142 Presumpscot St.

Warehouse Addition

**CITY OF PORTLAND, MAINE
DEVELOPMENT REVIEW APPLICATION
PLANNING DEPARTMENT PROCESSING FORM
Planning Copy**

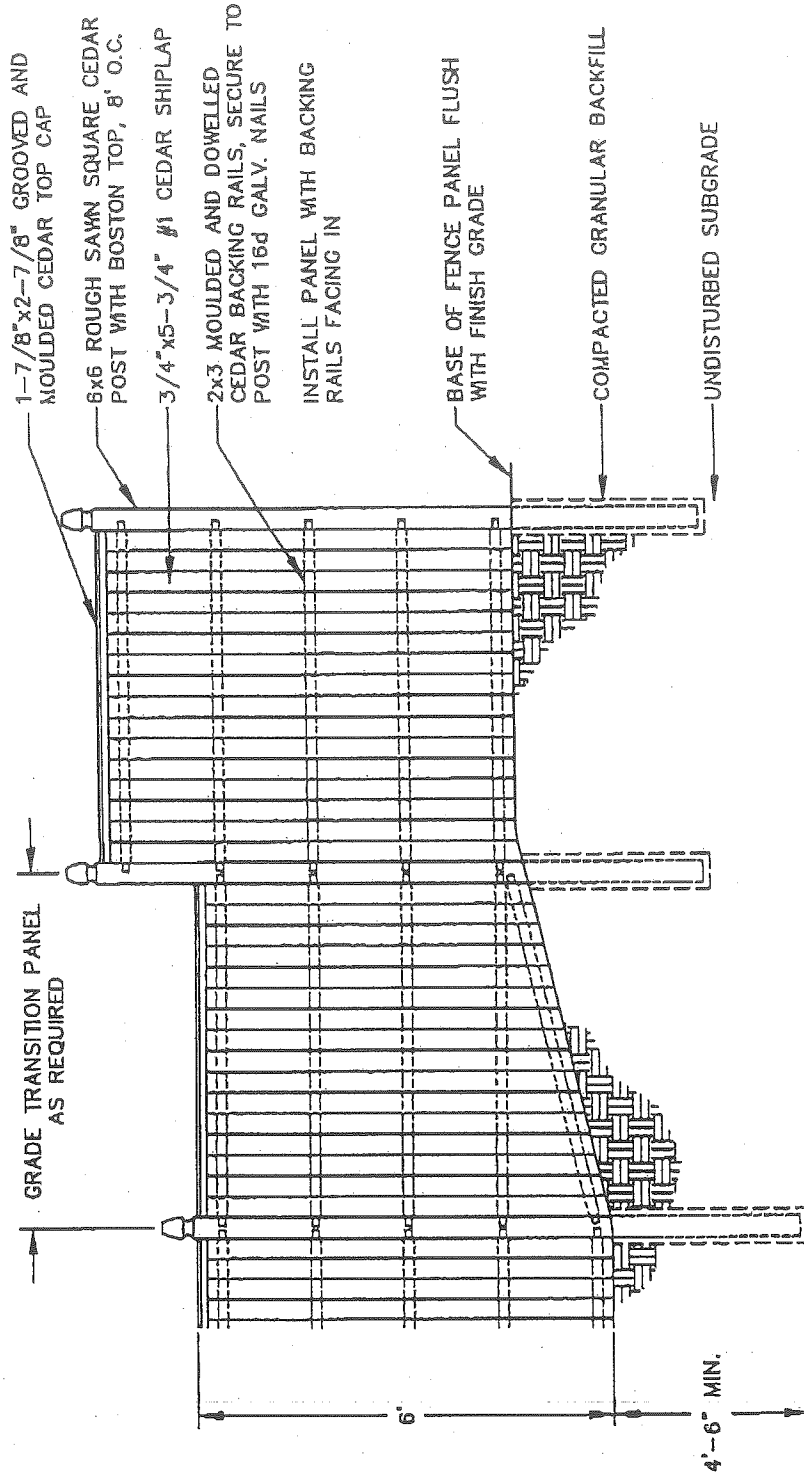
REMARKS: Urgent For your review Reply ASAP Please comment

Sarah:

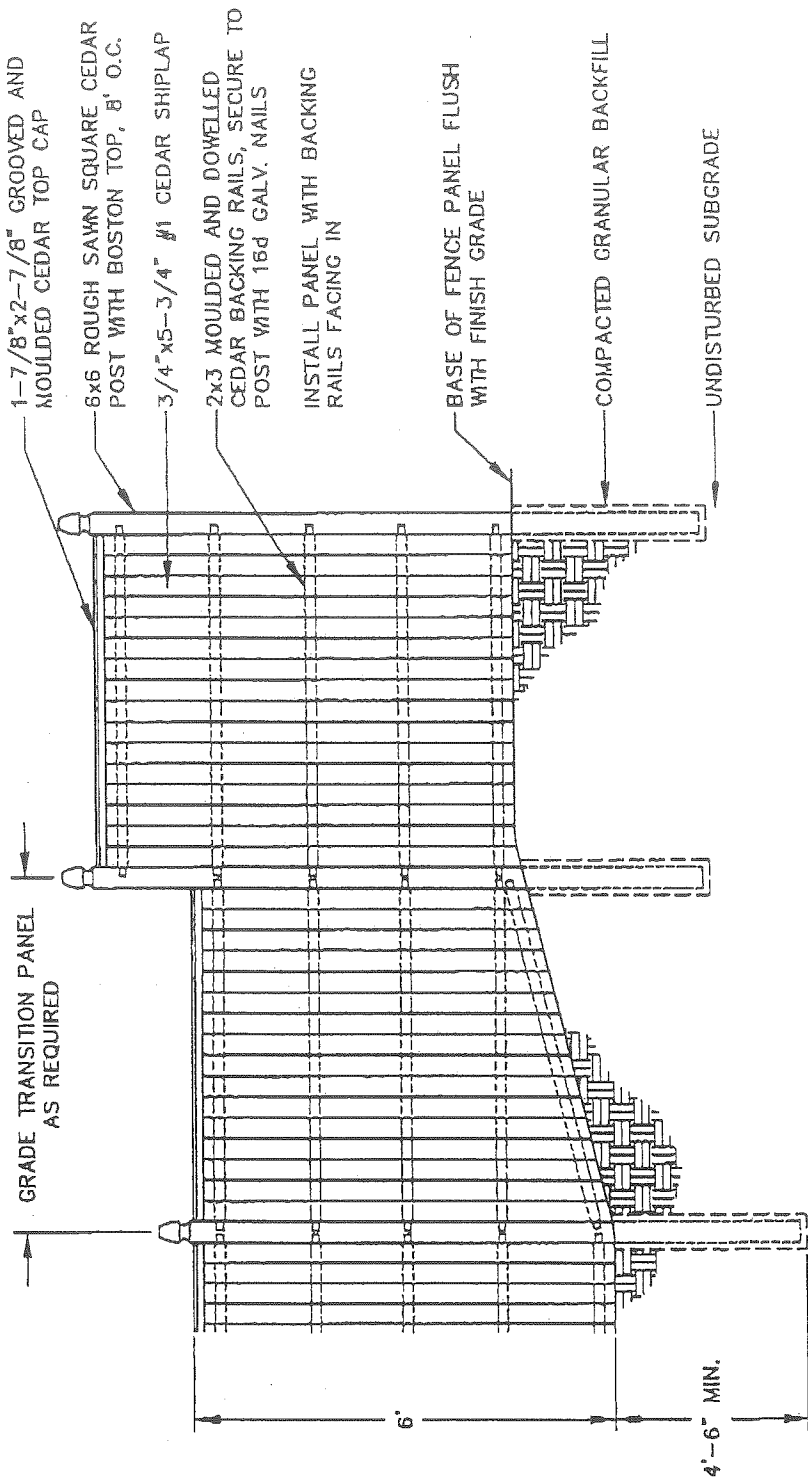
Sarah:

The attached details are what we would add to the plans to address the dumpster screening and the Casco Trap. The Casco Trap detail is straight from the City's Technical and Design Standards and if we can refer to the standard rather than creating the detail on the plans, it would save us time and money.
